Service Information Bulletin

****Notice of Recall 08V-290****

Subject: Gearbox Replacement

Model: R 1200 GS facelift (K25/11), R 1200 GS Adventure facelift (K25/12) and R 1200 R (K27)

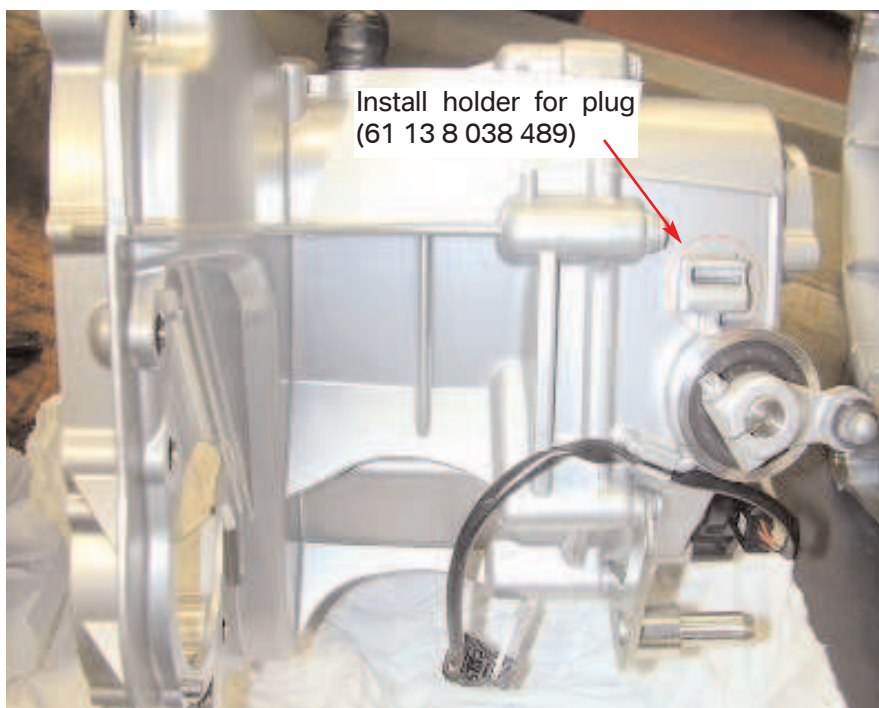
Aftersales Solution: All affected motorcycles must have the gearbox replaced. All new gearboxes are shipped dry, in other words without oil filling, and must be filled with oil before the motorcycles are used for the first time.
The gearboxes shipped from the factory are of the most recent design and incorporate modifications to the holder of the top cable guide of the gearbox potentiometer, so it is important to take the following into account:
The clip from the original gearbox can be re-used for the **bottom guide** of the gearbox-potentiometer cable.
In regards to the **top cable guide**, it is **not** possible to re-use the clip from the original gearbox. If no clip is enclosed with the replacement gearbox, the clip holder for plug (part number 61 13 8 038 489) has to be ordered from the electronic parts catalogue and installed. See photo of cable routing.
